**Independent Design Peer Review**

# CROWN STREET, SURRY HILLS DEVONSHIRE ST TO OXFORD ST UPGRADE PEER REVIEW

CITY OF SYDNEY  
MARCH 2023  
FINAL

STATUS	FINAL
ISSUE	D
DATE	03,03,2023
PREPARED BY	GJ/ZY
APPROVED BY	JP

### Crown Street Peer Review Plan 4 of 8

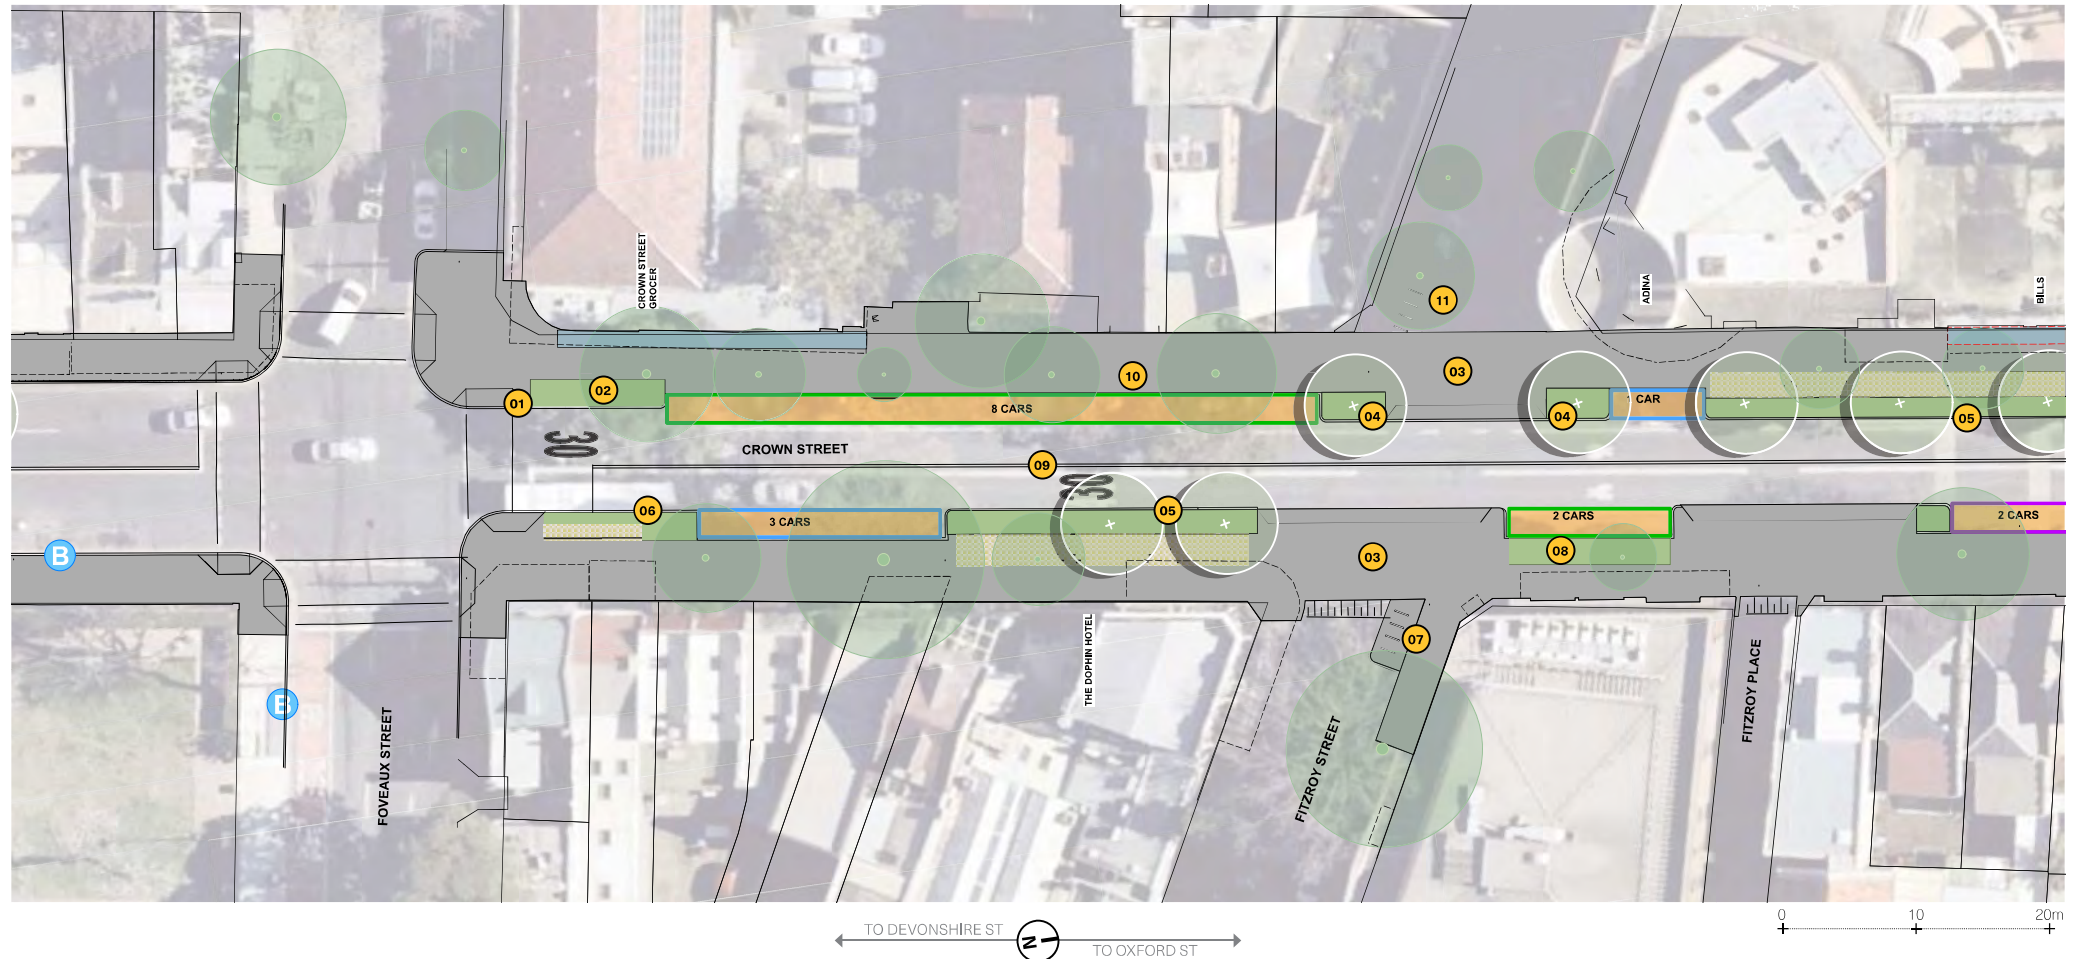
1. Kerb extension as per AECOM concept design.
2. Additional kerbside planting.
3. Continuous footpath treatment and kerb extension at Fitzroy St.
4. Kerb extension with new street tree planting.

5. New kerb extension to create activation area with kerbside planting and additional street trees at existing commercial premises.
6. New kerb extension to provide additional pedestrian paving for activation and planting. Adjustment to signal operations to be investigated (subject to TfNSW approval).

7. Kerb extension to Fitzroy Street to provide additional space for new bike parking.
8. Kerb alignment adjusted (to minimum compliant parking space width) to maximise footpath and planting space.

9. Speed reduction to Crown Street to 30km/h (subject to TfNSW approval).
10. Existing driveway removed as per current concept design.
11. Provide additional bike parking on Arthur St to offset removal/relocation of existing bike parking on Crown St.

### Crown Street Peer Review Plan 5 of 8

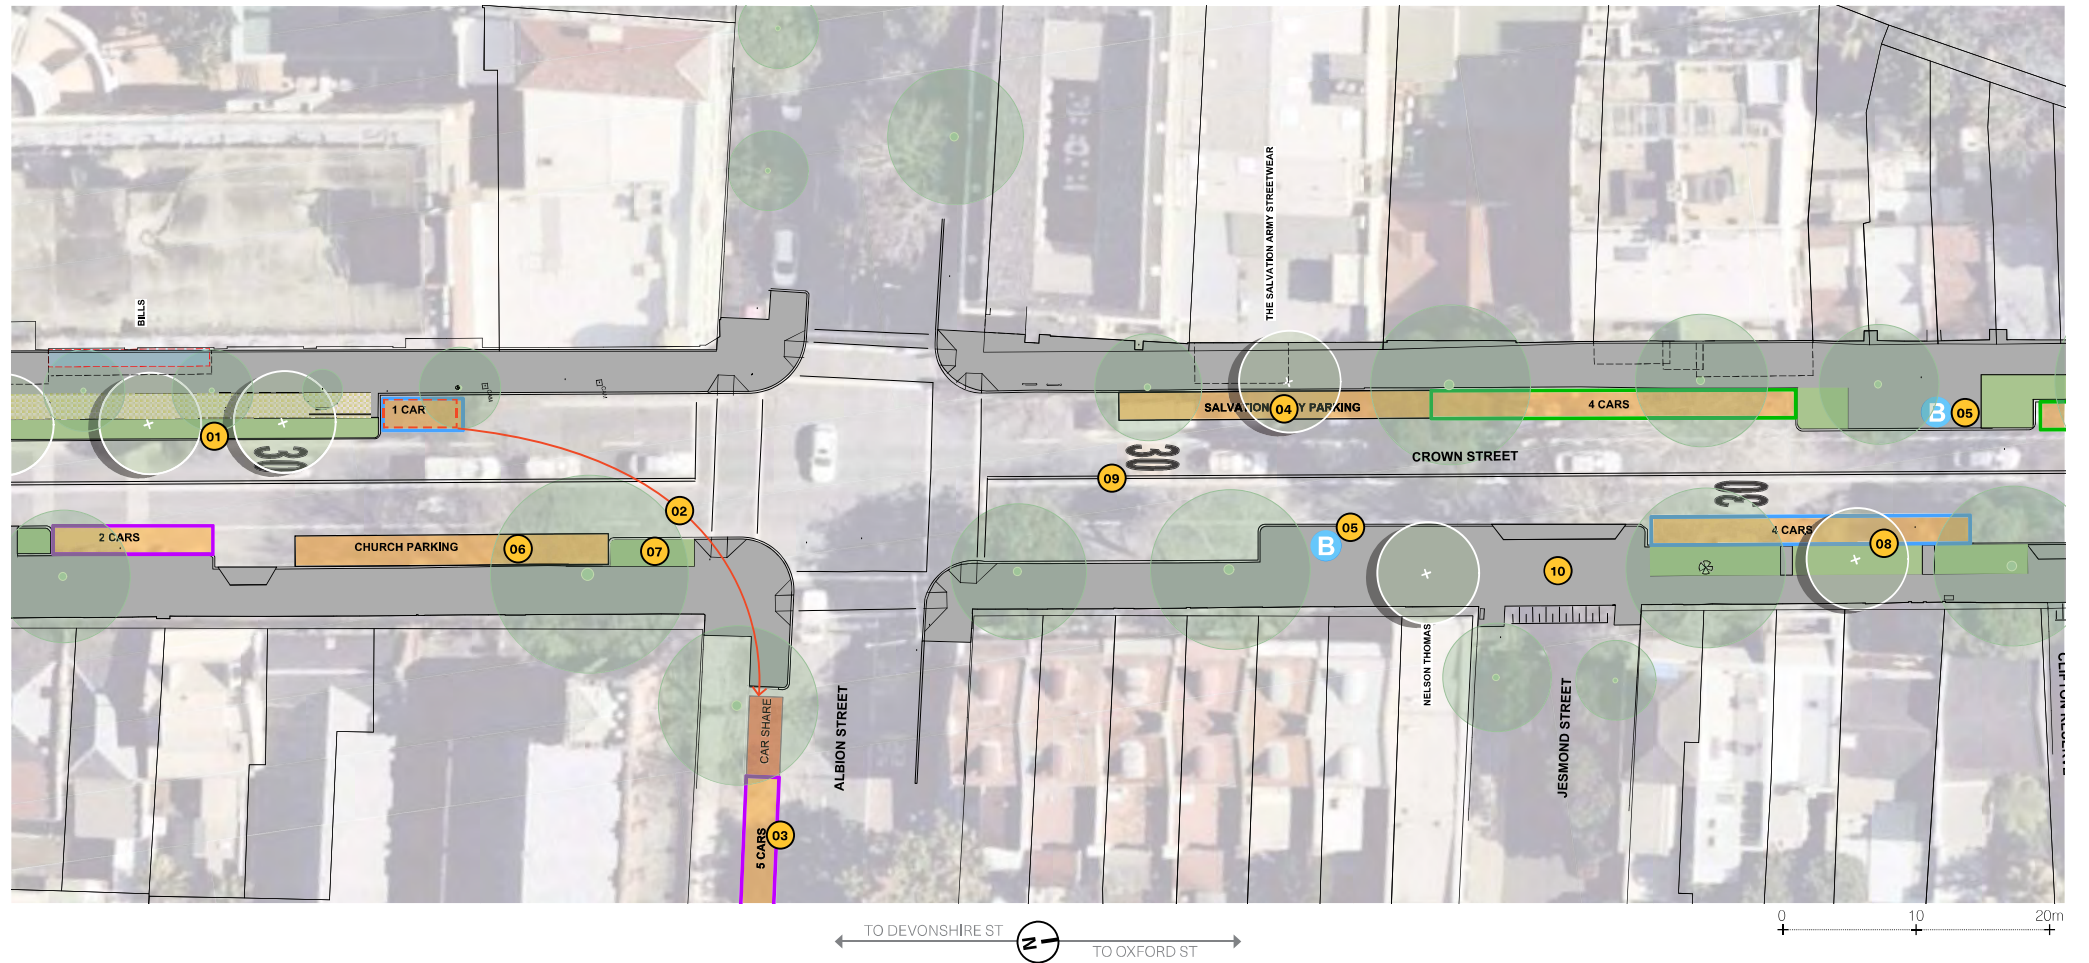
1. New kerb extension to create activation area with kerbside planting and additional street trees at existing commercial premises.
2. 1x car share relocated to Albion St, replaced with 2P parking space.

3. Convert 6 no. existing unmarked 2P parking spaces on Albion St to 5 no. marked 2P parking spaces.
4. Existing Salvation Army parking area. Investigate opportunity to introduce Loading Zone and/or after-hours general parking (subject to further consultation).

5. New kerb extension for in-lane bus stop, 9m paving zone shown, to be reviewed at detailed design stage to consider user access requirements (subject to approval by TfNSW).

6. Existing signed church parking area. Investigate opportunity to introduce timed after-hours general parking (subject to further consultation).
7. Kerb extension to provide additional pedestrian paving and planting at intersection.

8. Kerb alignment adjusted (to minimum compliant parking space width) to maximise footpath and planting space. Continuous planting bed provided with intermittent pavements for access to parked vehicles.

9. Speed reduction to Crown Street to 30km/h (subject to TfNSW approval).
10. Continuous footpath treatment and kerb extension at Jesmond St.

### Crown Street Peer Review Plan 6 of 8

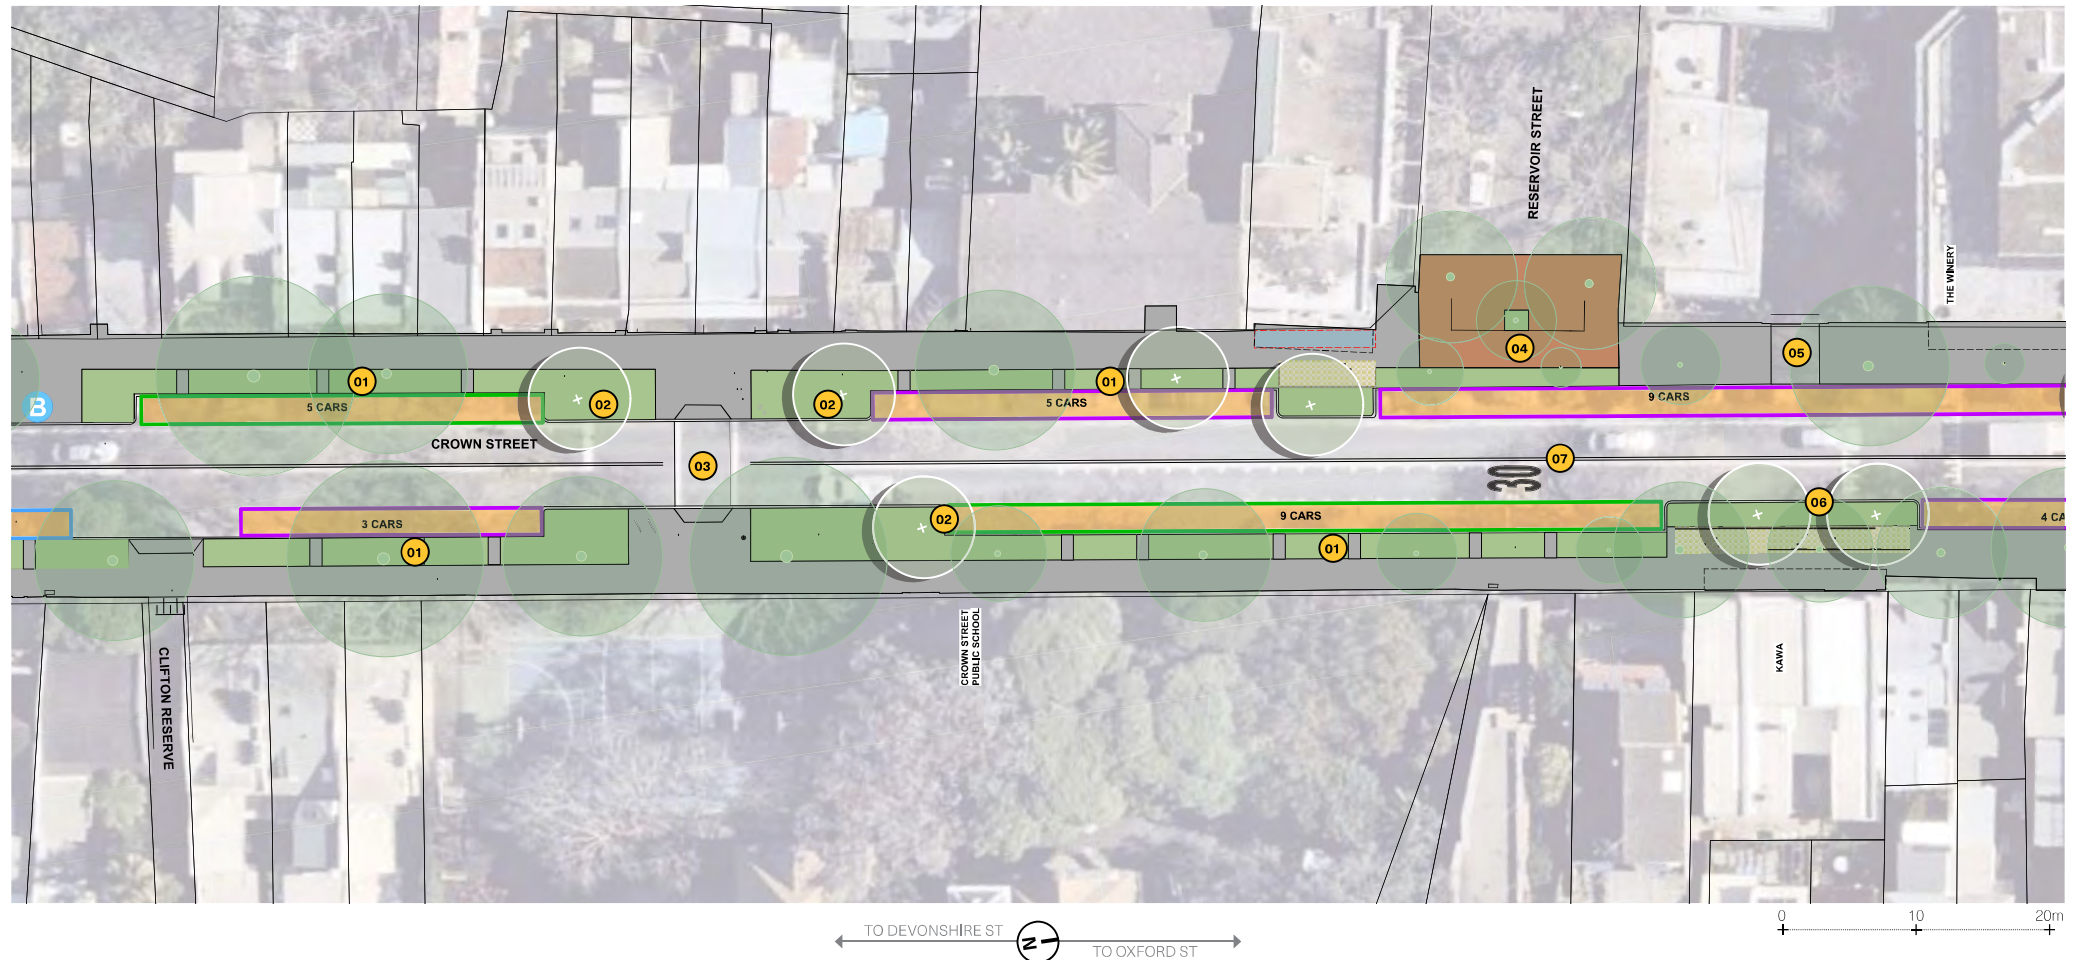
1. Kerb alignment adjusted (to minimum compliant parking space width) to maximise footpath and planting space. Continuous planting bed provided with intermittent pavements for access to parked vehicles.
2. New kerb extension with planting and street trees to provide additional canopy cover.
3. Existing signalised crossing retained in current location.
4. Existing brick paving to full width of Reservoir St lot boundary to be retained.
5. Existing heritage driveway retained.
6. New kerb extension to create activation area with kerbside planting and additional street trees at existing commercial premises.
7. Speed reduction to Crown Street to 30km/h (subject to TfNSW approval).

### Crown Street Peer Review Plan 7 of 8

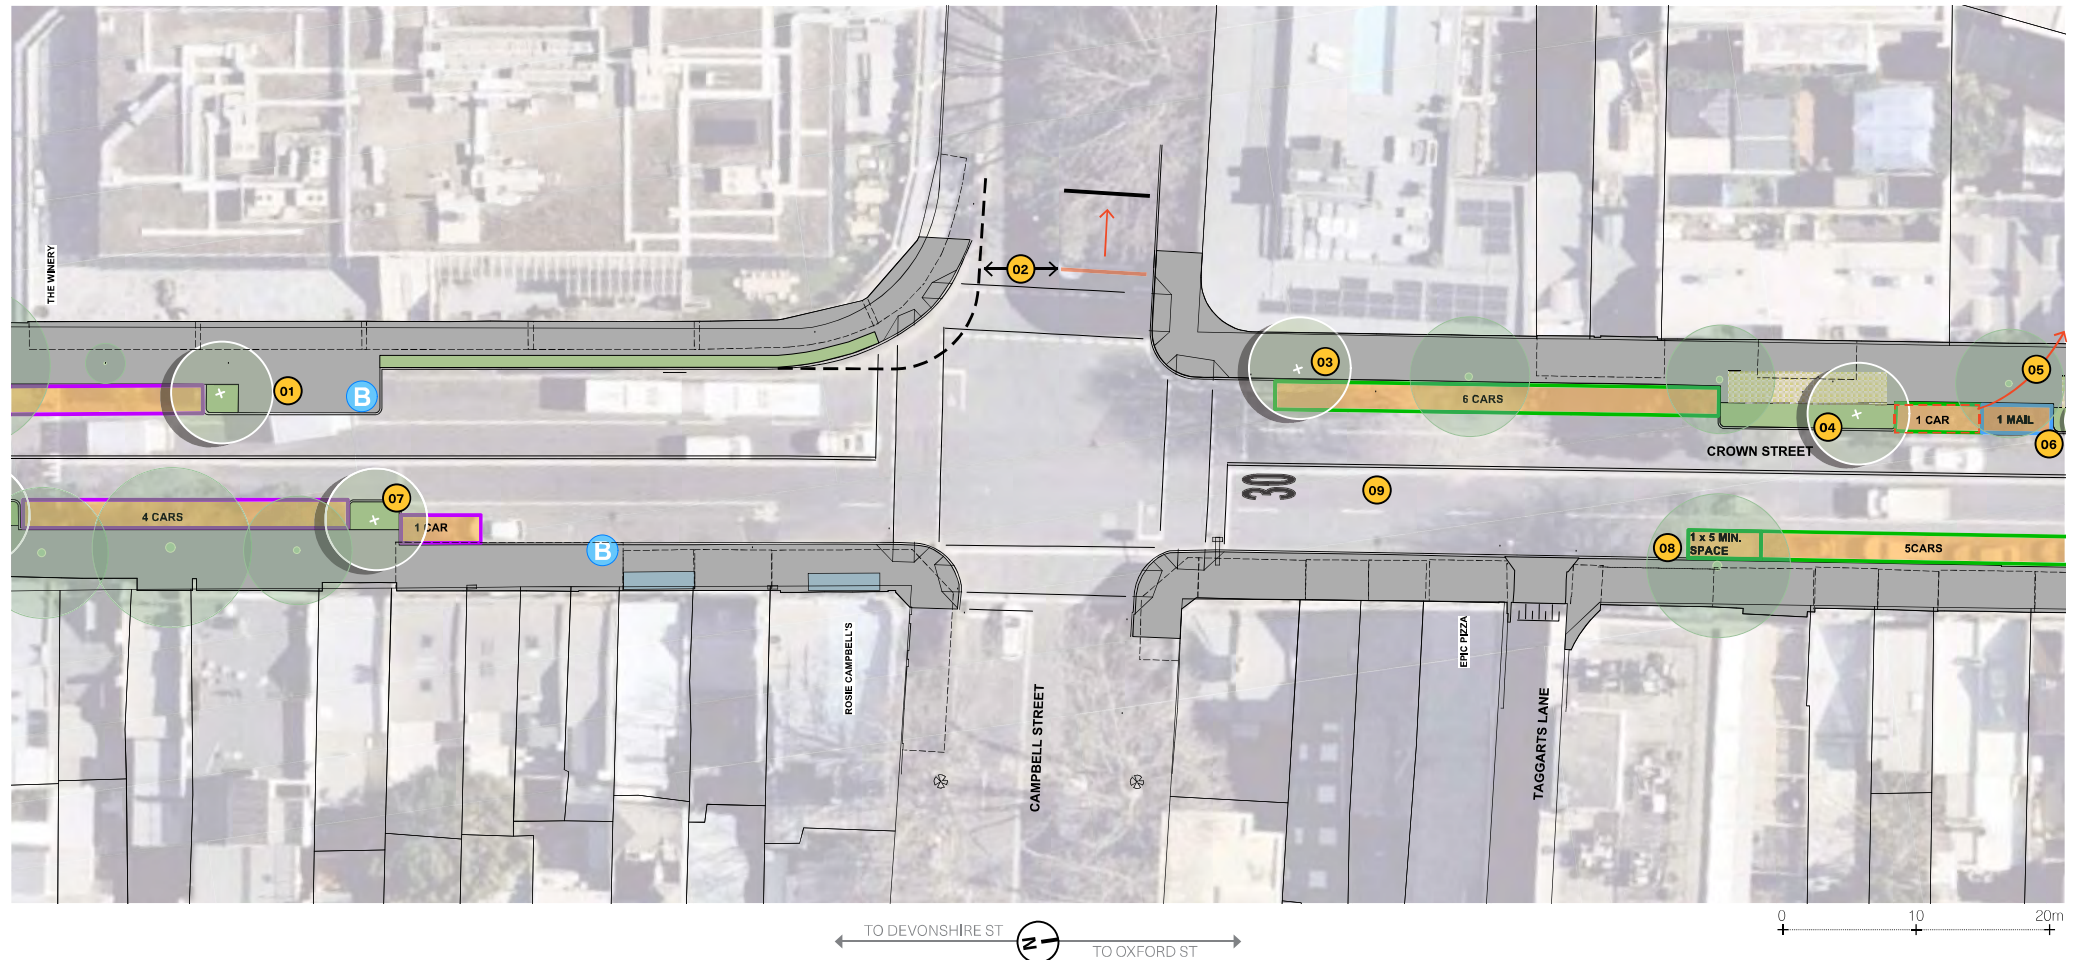
1. New kerb extension for in-lane bus stop to alleviate constrained footpath space where bus stop furniture is currently installed. New planting bed and street tree provided within kerb extension.
2. Explore potential for traffic stop line relocation on Campbell St to allow for kerb radius reduction without impeding vehicle turning movements.
3. New street tree in tree pit.
4. New kerb extension to create activation area with kerbside planting and additional street tree at existing commercial premises.
5. Relocate 1 no. existing car share parking space to Goulburn St (refer to next sheet for location of new car share space).
6. Existing mail parking space retained.
7. New street tree in kerb extension.
8. Convert existing no parking area to 1 no. 5 minute P line marked parking space.
9. Speed reduction to Crown Street to 30km/h (subject to TfNSW approval).
